To: T10 SAS Protocol Working Group

From: Brian Day [and George Penokie](#)

Subject: SAS 2.1 / [SPL+](#) : 08-249 Link Layer Power Management

Figure 1 — SL (link layer for SAS logical phys) state machines (part 1)

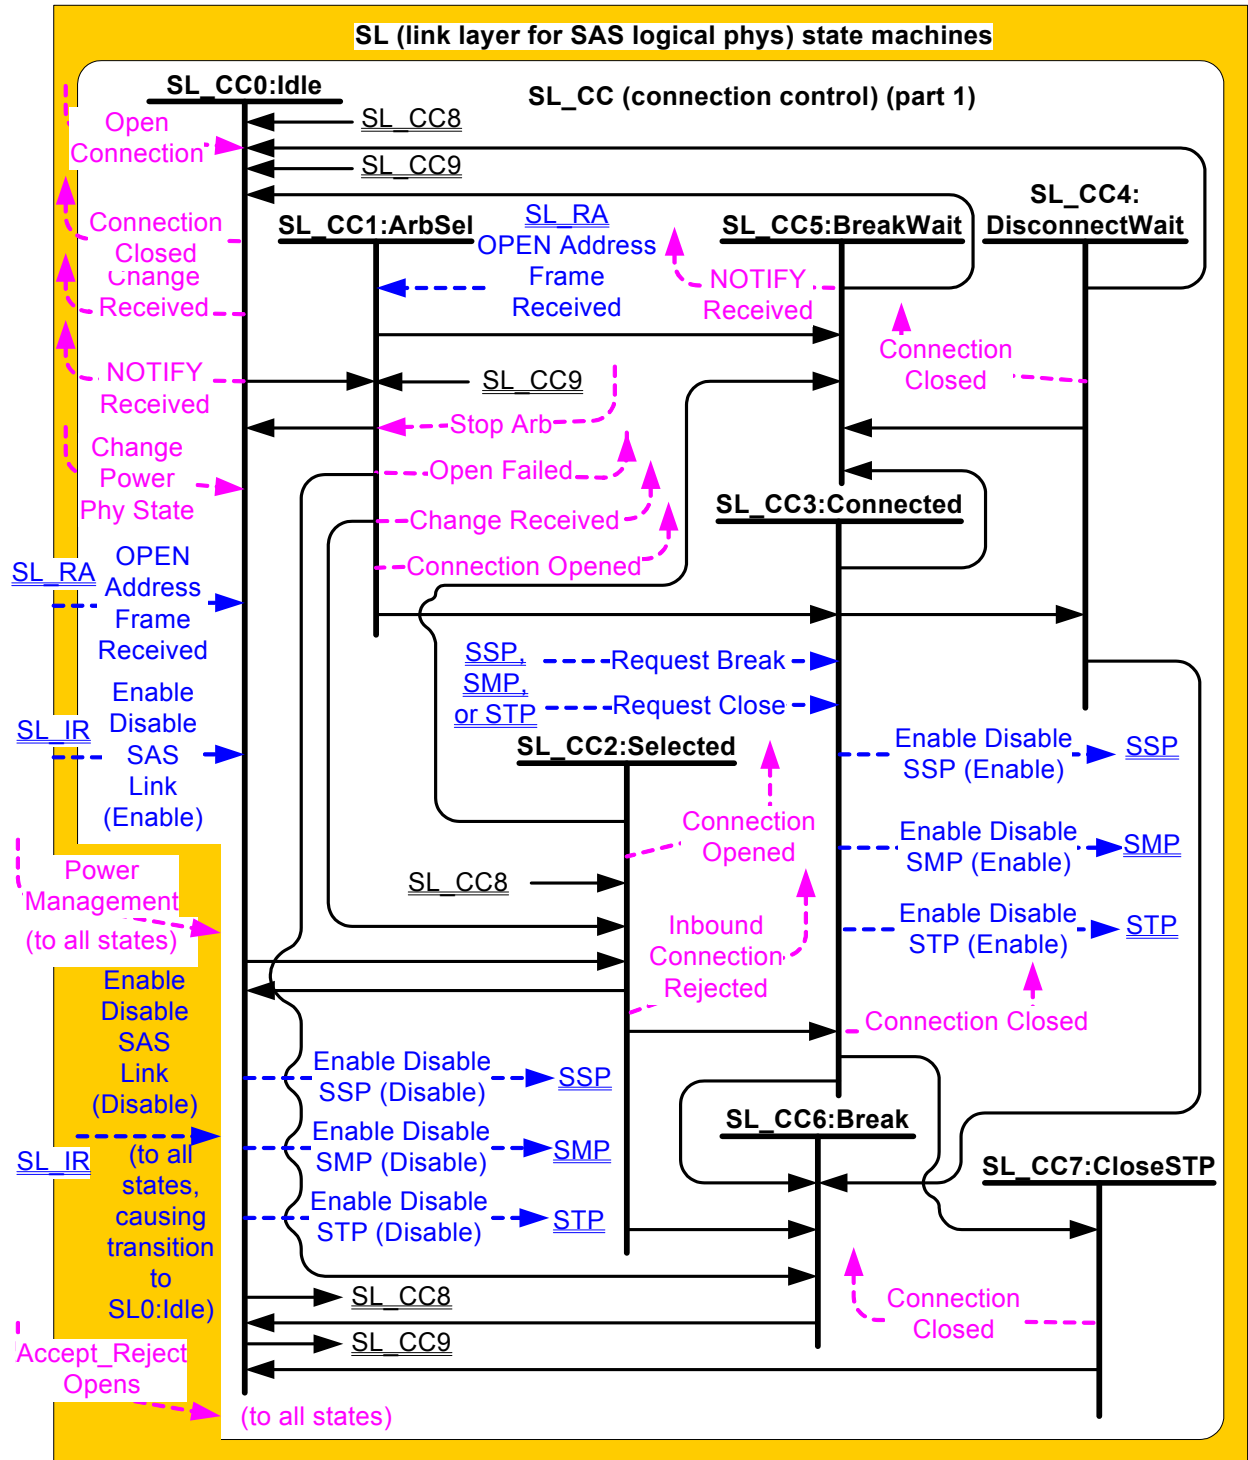
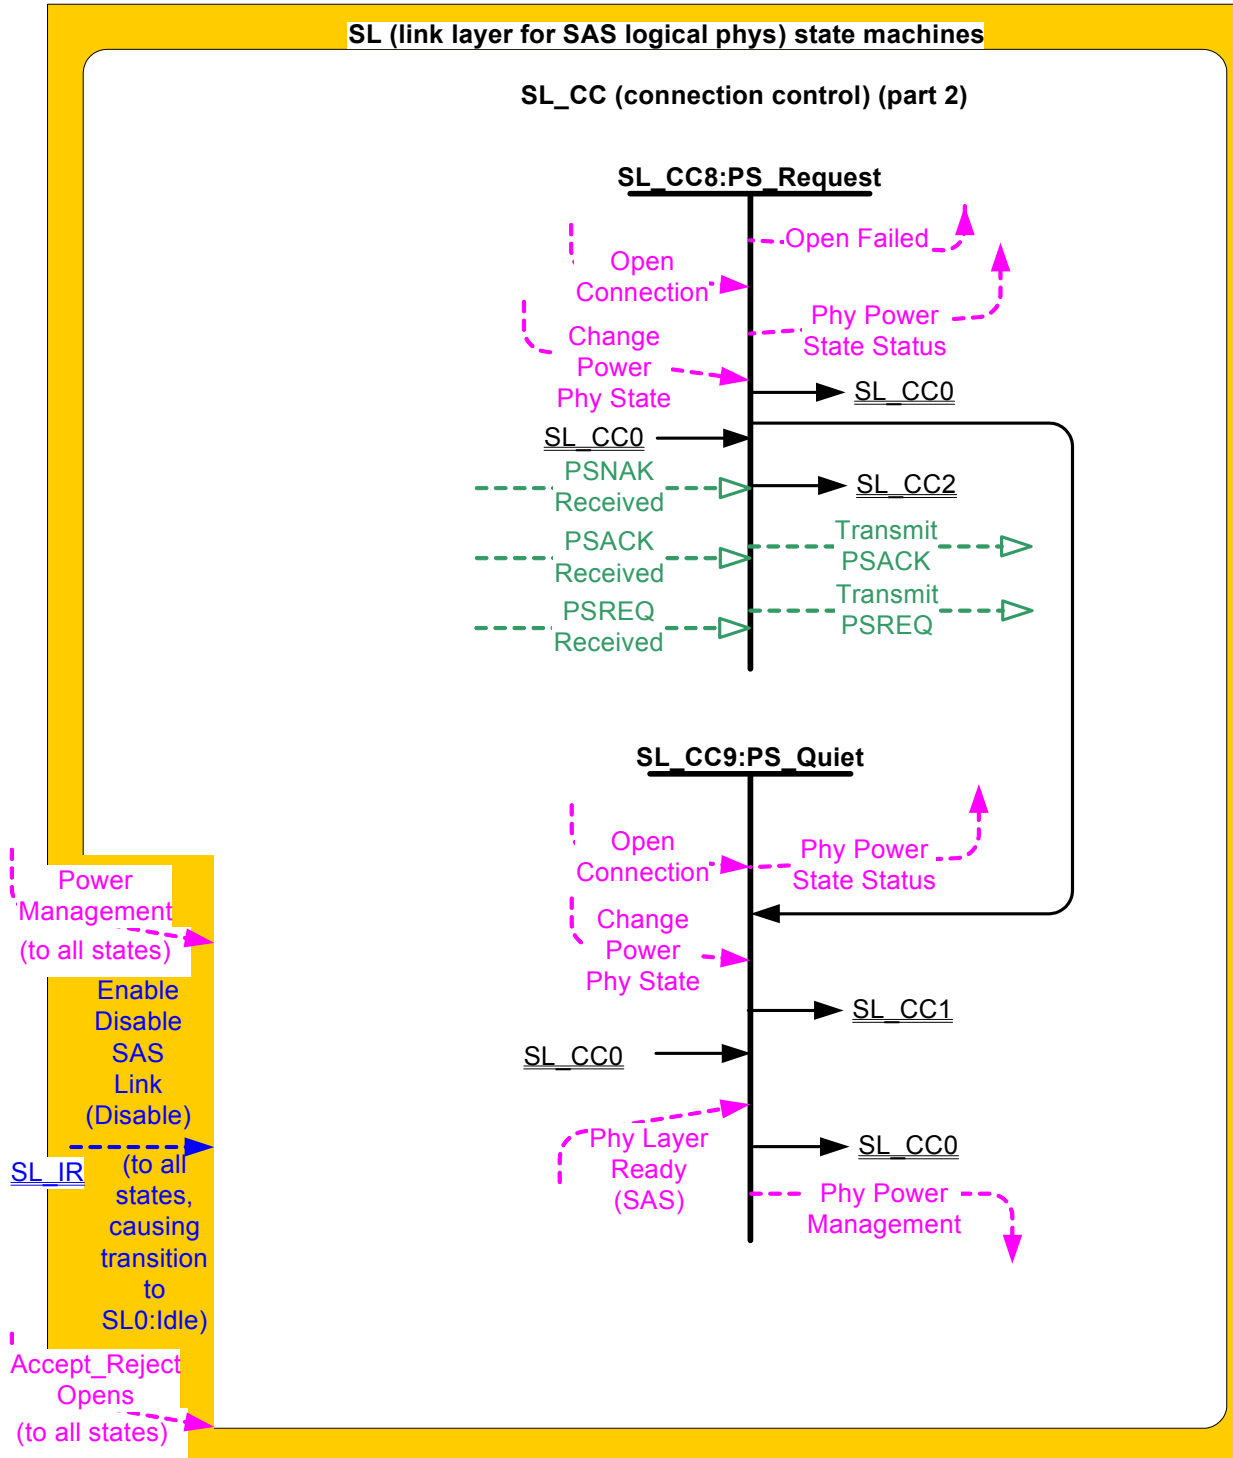
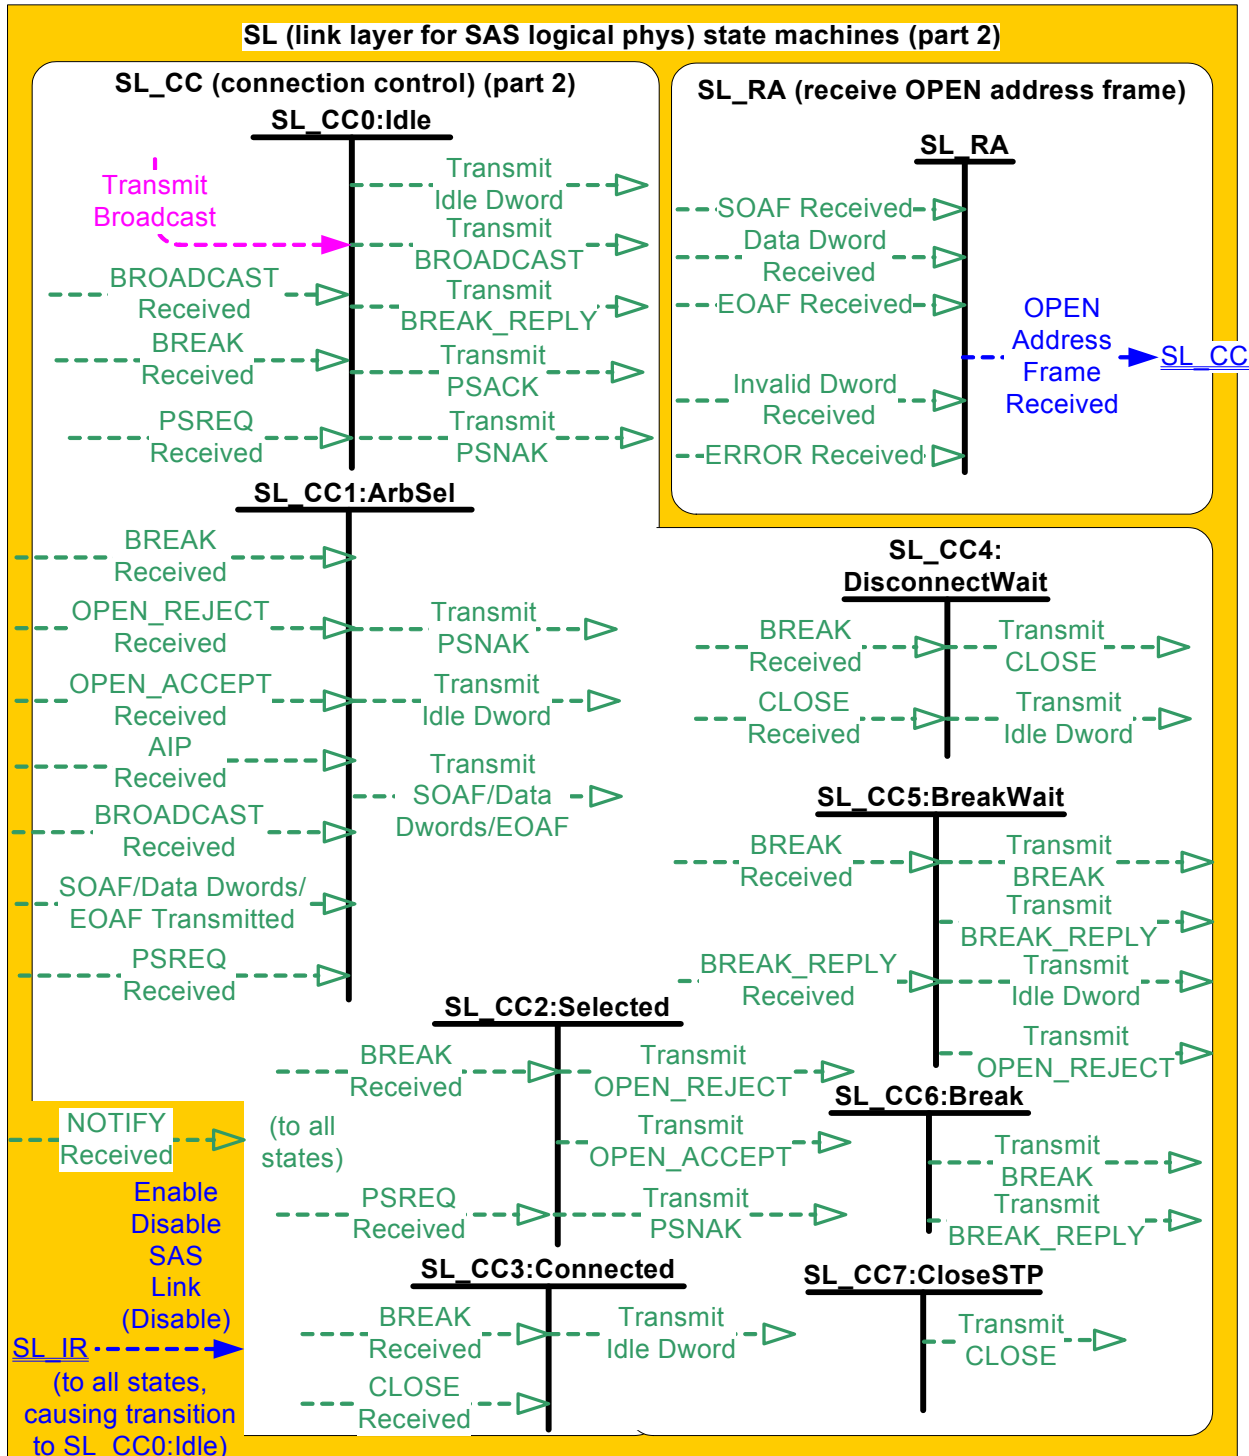
[Editor's Note 0: Need to update figures with new states, and with Request Power Management request coming down, and Phy Power confirmation coming up.](#)

Figure 4 — XL (link layer for expander logical phys) state machine (part 1)

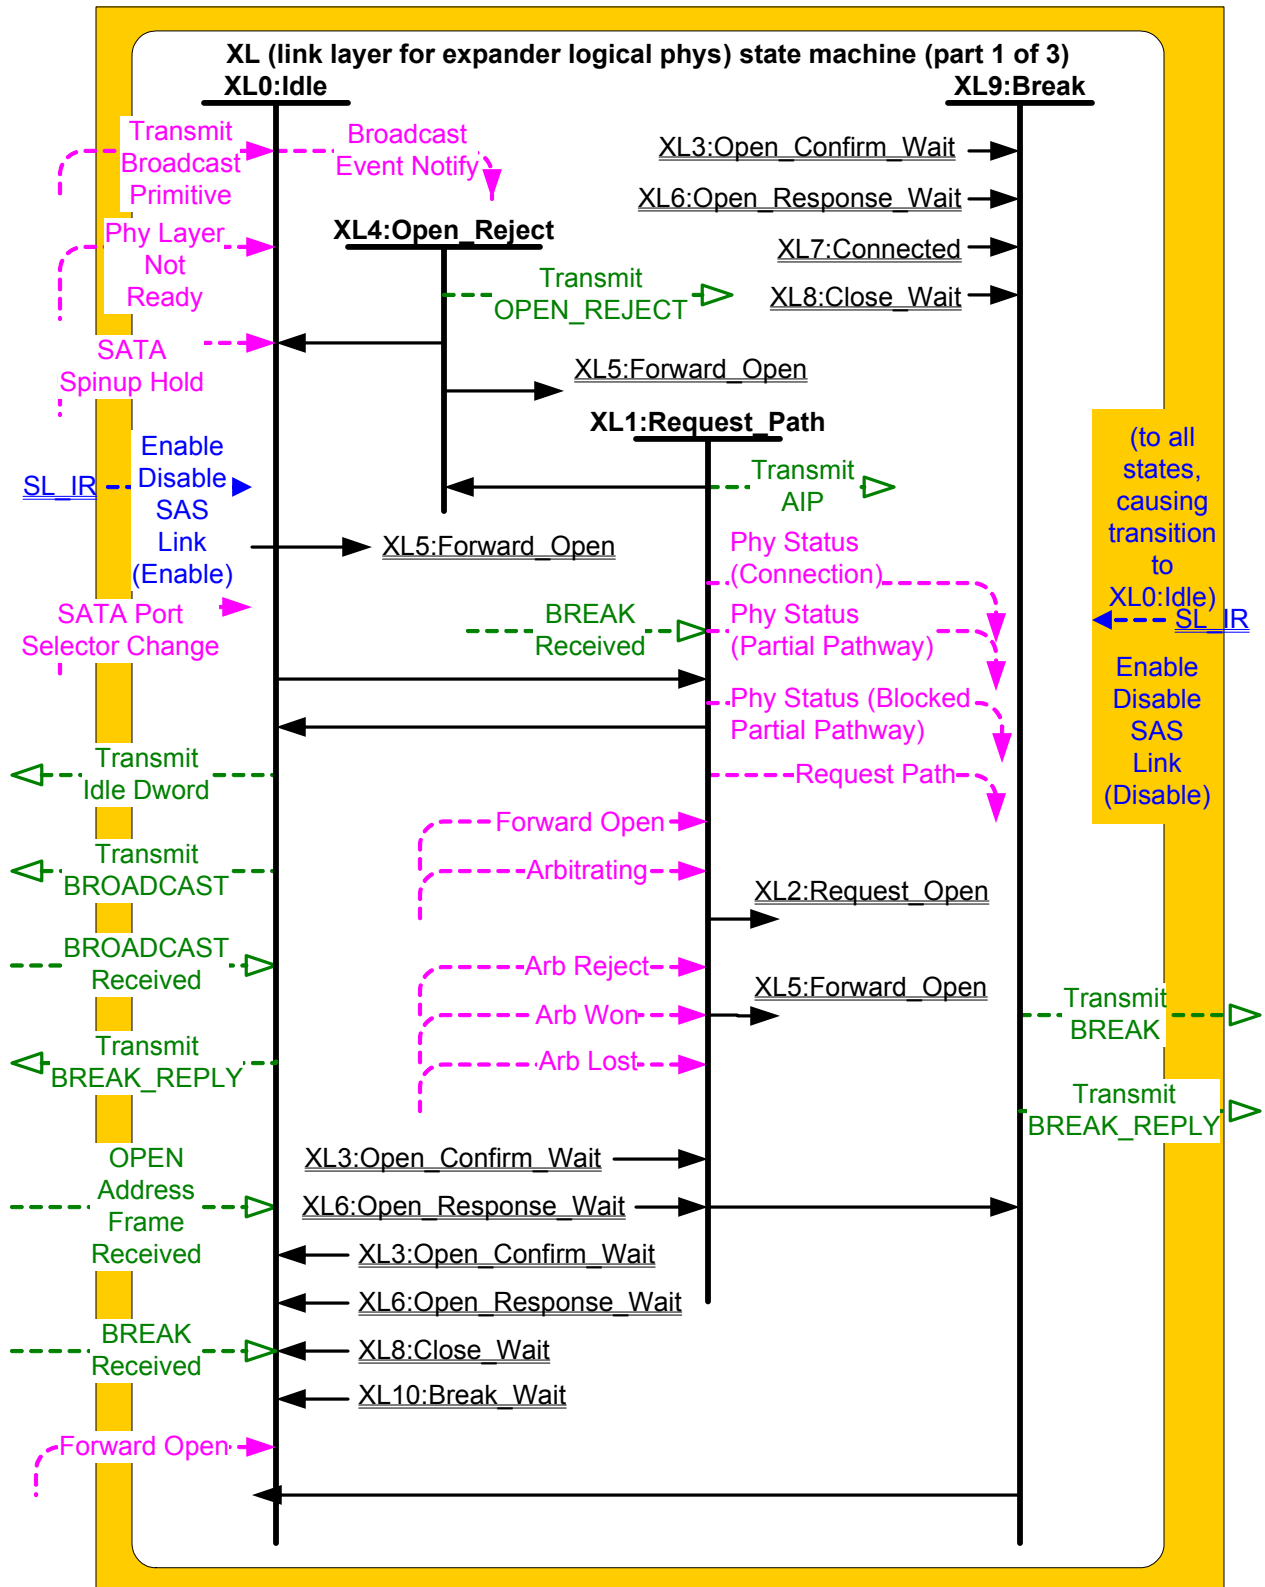
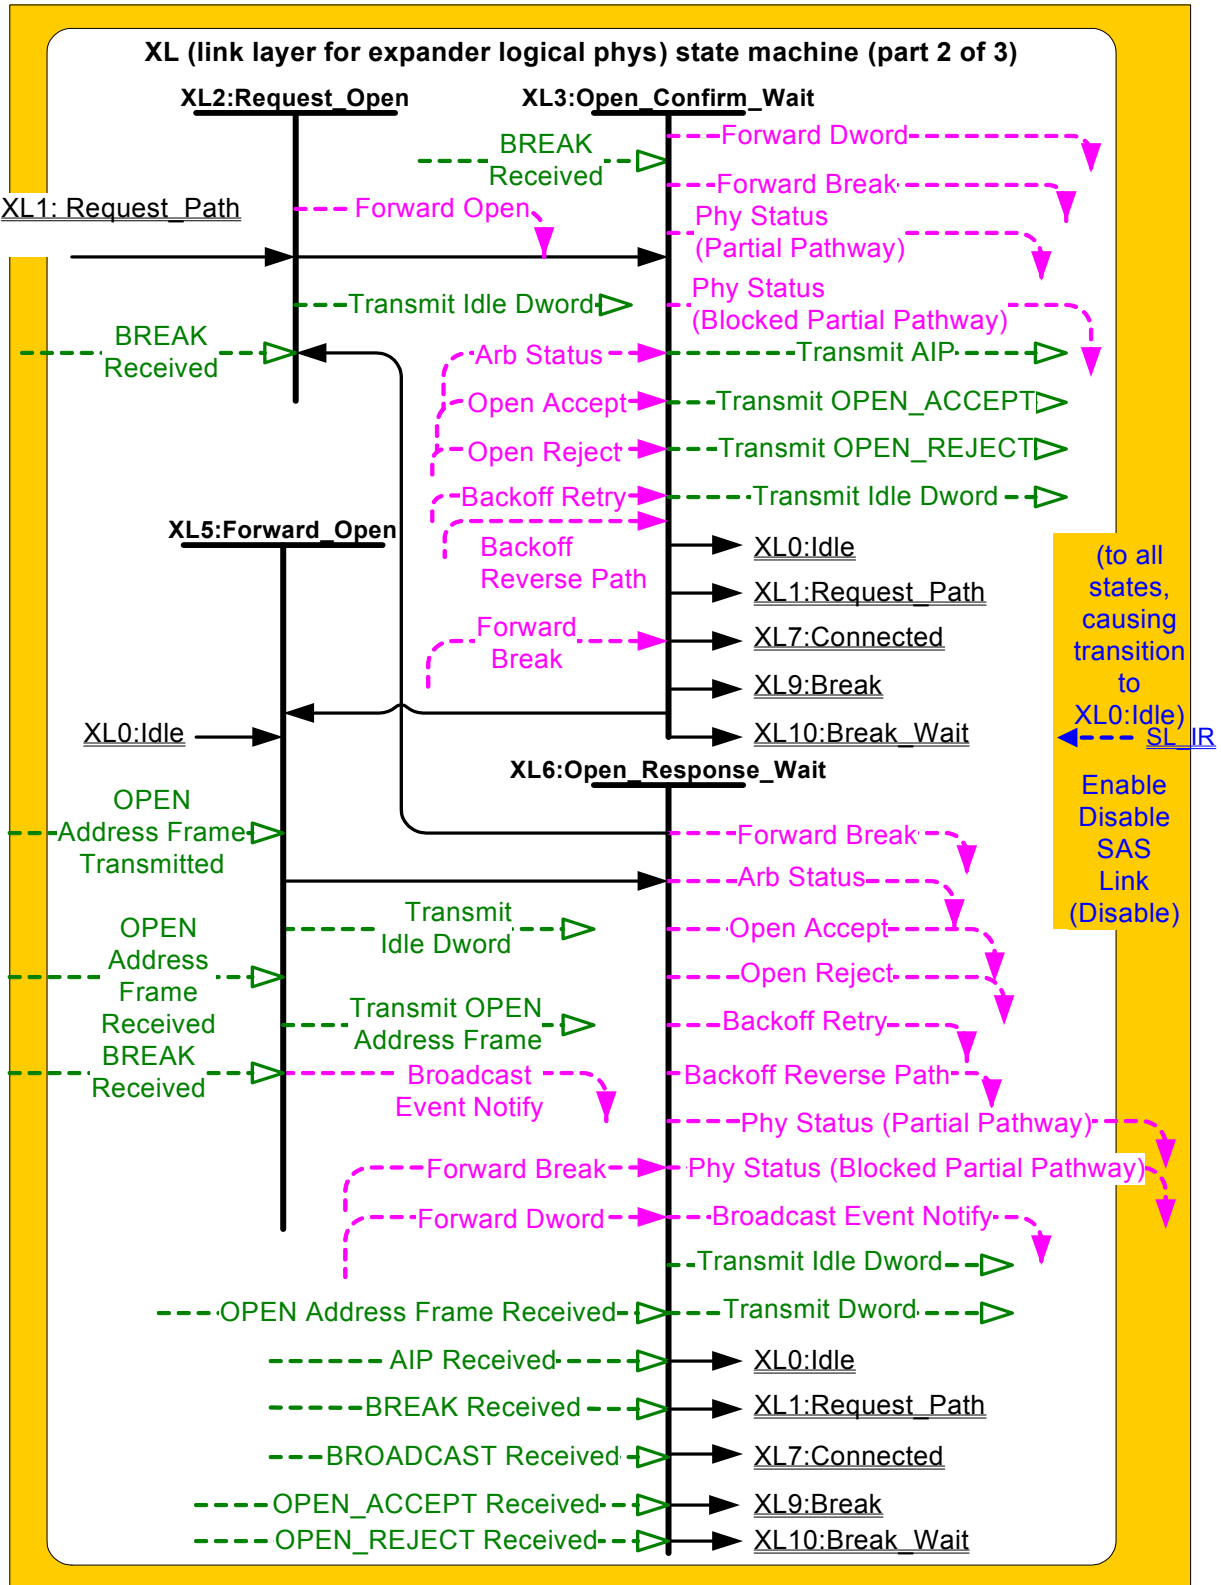
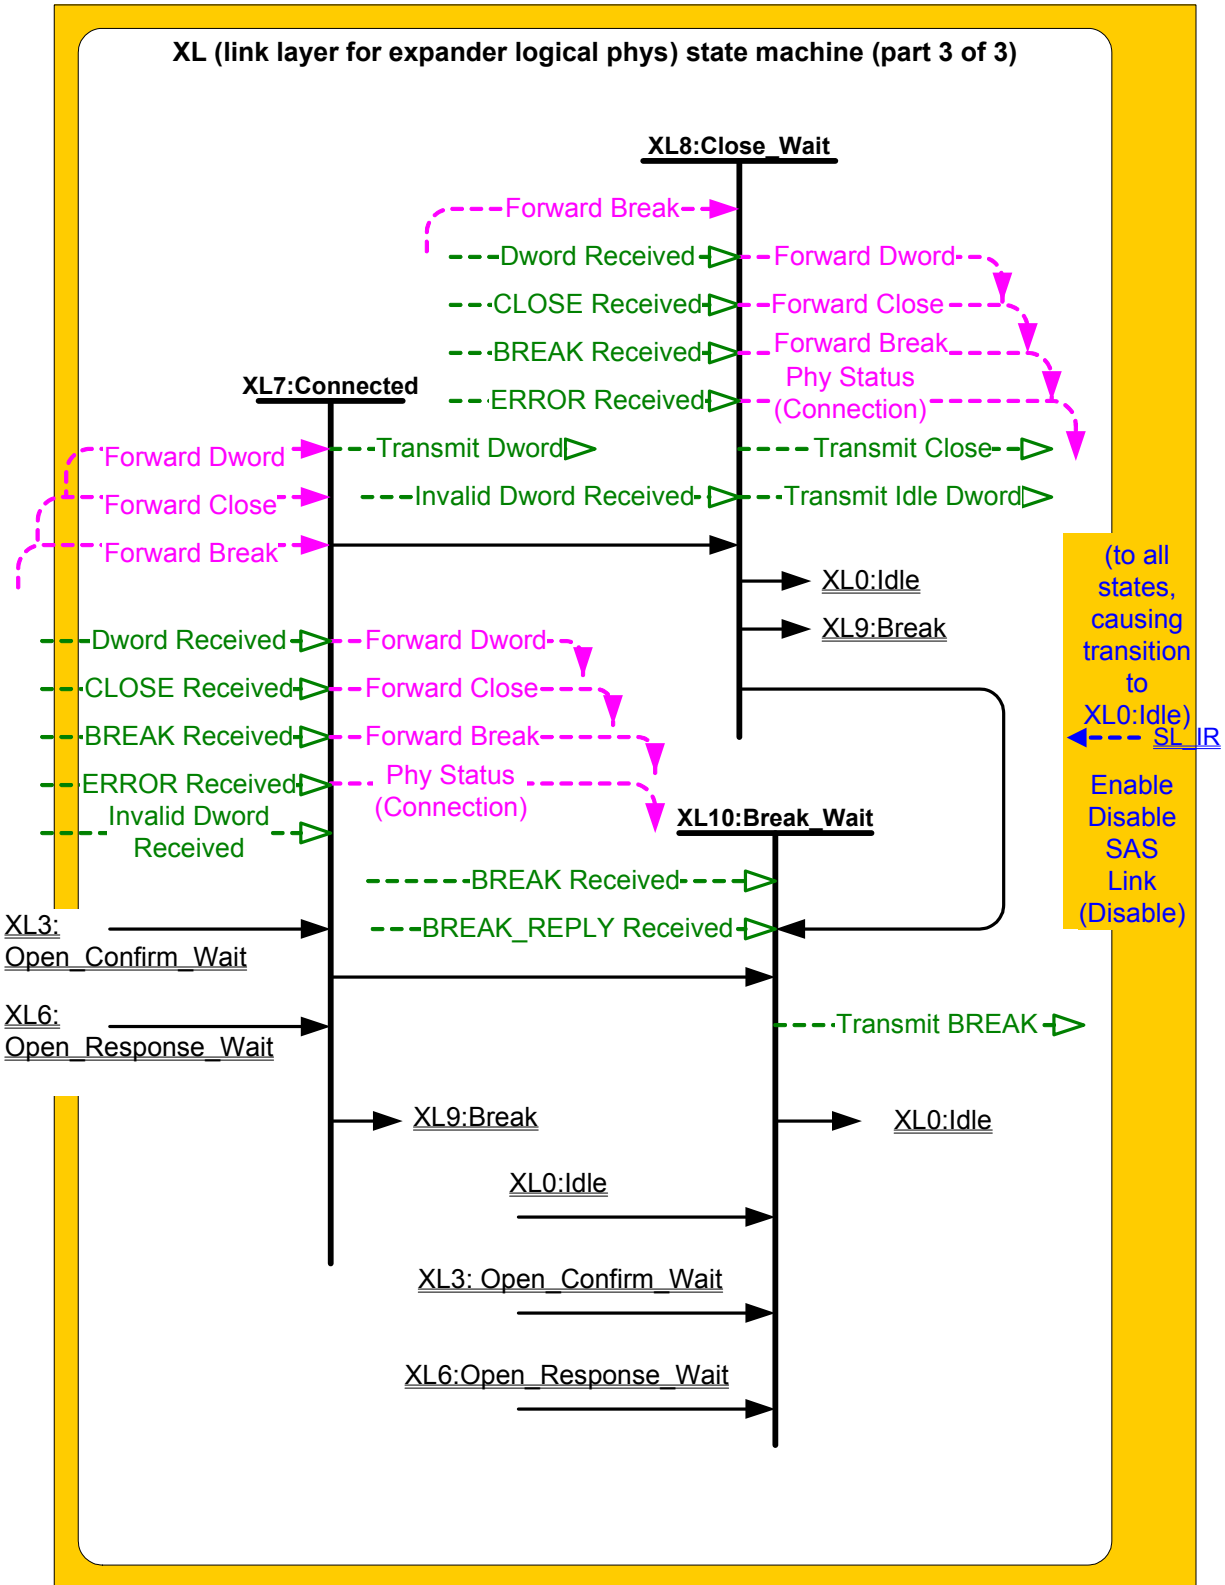
Editor’s Note 11: Need to update figures with new states, and with Request Power Management request coming down, and Phy Power confirmation coming up.
